Product Change Notice (PCN)

PCN Number: PCN-0370542-01

CMT-8504-100-SMT-TR

OLD

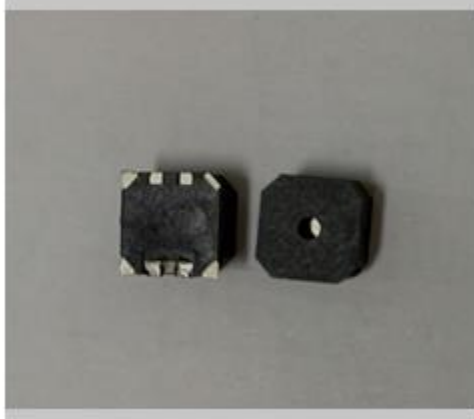
Improving the structure by changing the bottom to integrated with injection molding, and the connection parts being put inside. The item will now be done by machine to increase the capacity of production.

NEW

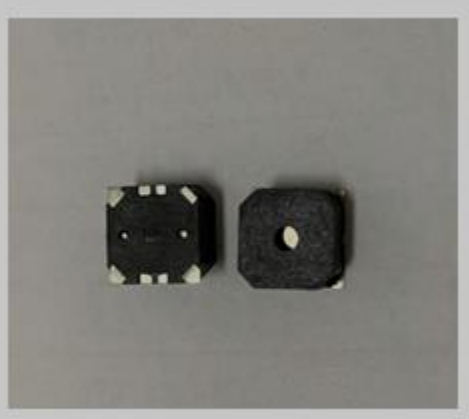
The only change is the injection Molding. This does not change any of the Characteristics of the product.
